CAIRNGORMS NATIONAL PARK AUTHORITY

DEVELOPMENT PROPOSED: Lethen wind farm	
Consultation from Scottish Government Energy Consents and Deployment Unit	
REFERENCE:	2022/0021/PAC (ECU00002216)
APPLICANT:	Fred Olsen Renewables
DATE CONSULTED:	6 January 2022
RECOMMENDATION:	Objection
CASE OFFICER:	Nina Caudrey, Planning Officer (Development Planning and Environmental Advice)

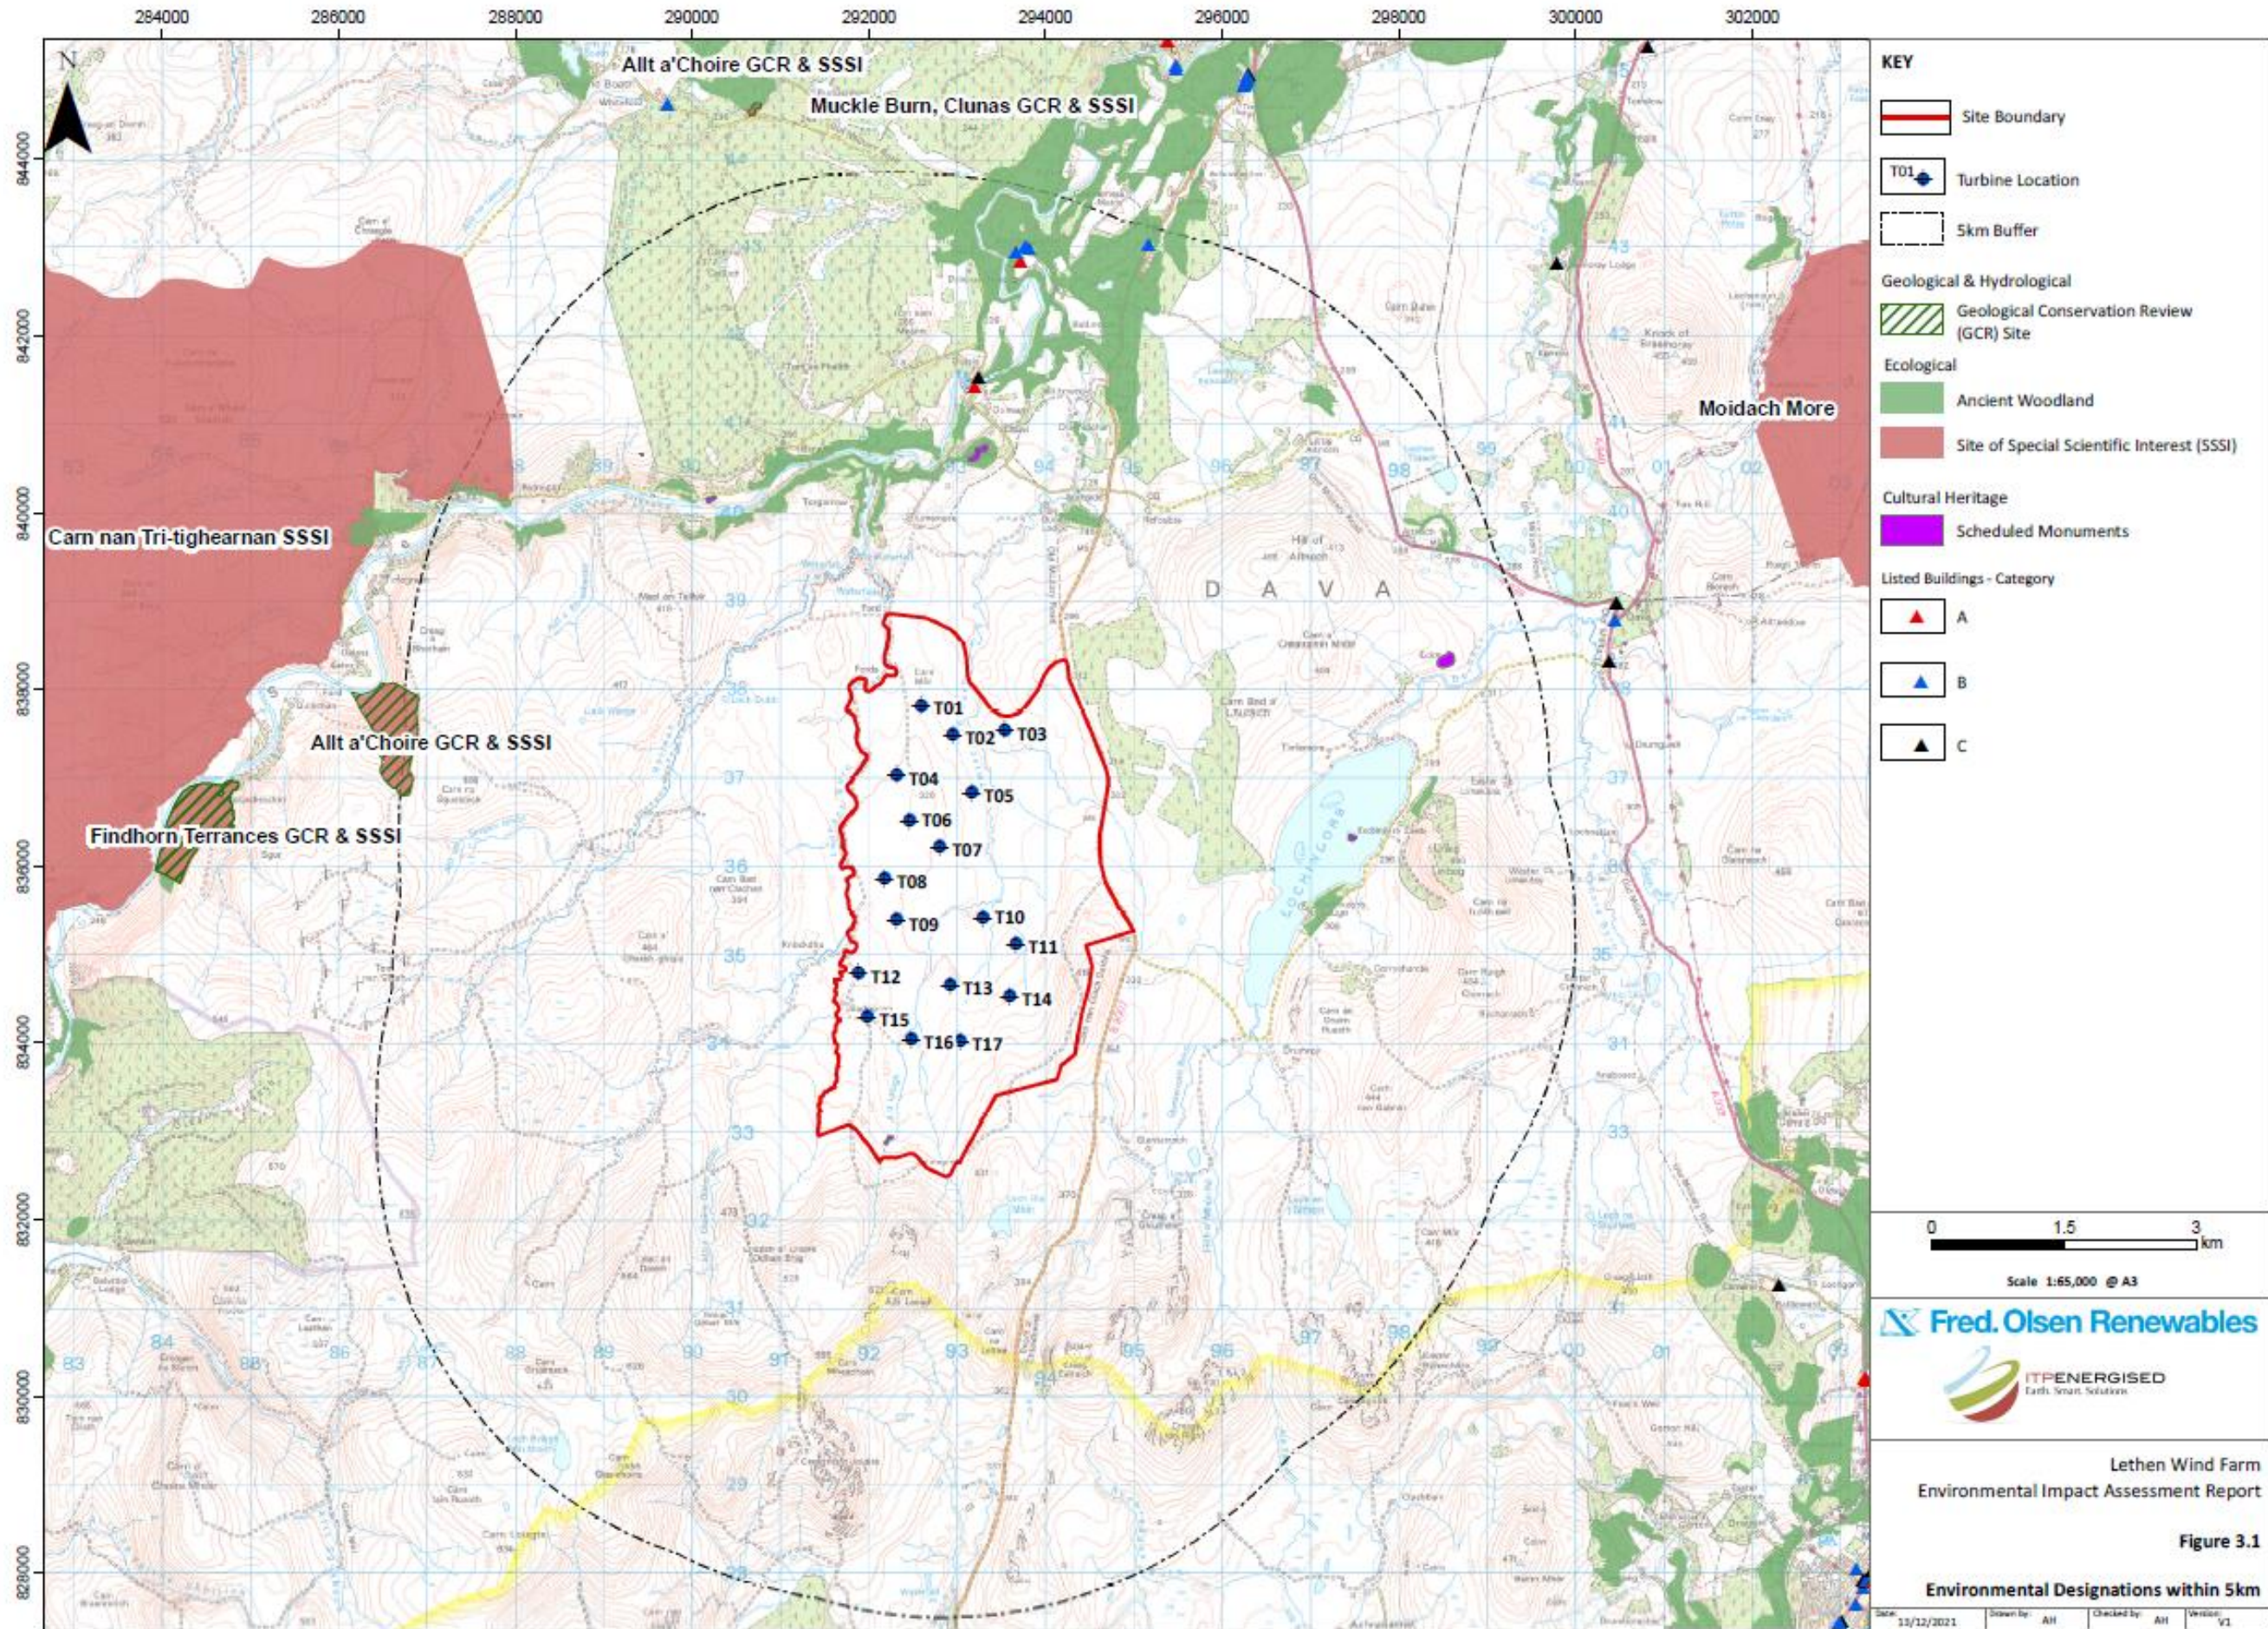
4. The proposed wind farm would be located approximately 10 kilometres (km) north-west of Grantown and 2.5km to the west of Lochindorb, as shown in the applicant's figure 3.1 on page 2 of this report (the edge of Grantown being shown in the bottom right hand corner of the figure).
